# City of Santa Fe, New Mexico

# memo

2025-010495-HDRB, 439 Camino del Monte Sol Lot 1-A, Downtown & Eastside Historic District, Significant, Hoopes Architects, agent for Chris Greulich and Mathew Boland, owners, request approval to construct a 504 sq. ft. detached garage to a height of 10'-3" where the max allowable is 14'-0".

Figure 4. Proposed Site Plan.

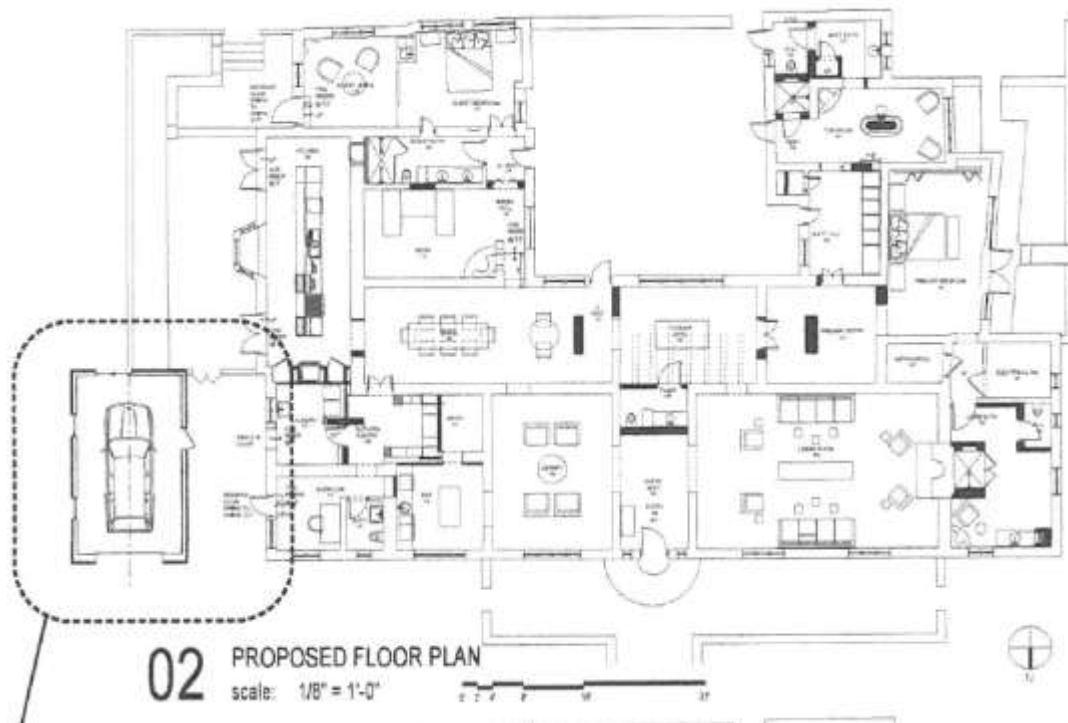
The proposed detached garage will be finished with adobe brown stucco to match the existing house and have a wooden garage door. The structure will be set back to the east by 10 feet from the existing east elevation. The proposed garage structure will be comparable to and compatible with the existing architectural style of the structure.

- 1) Construct a detached one-car garage on the east elevation to a height of 10'-3" where the maximum allowable is 14'.

Staff recommends approval of the proposed project and finds that the application complies with Section 14-5.2(D) General Design Standards for all Historic Districts, and 14-5.2(E) Downtown and Eastside Design Standards.
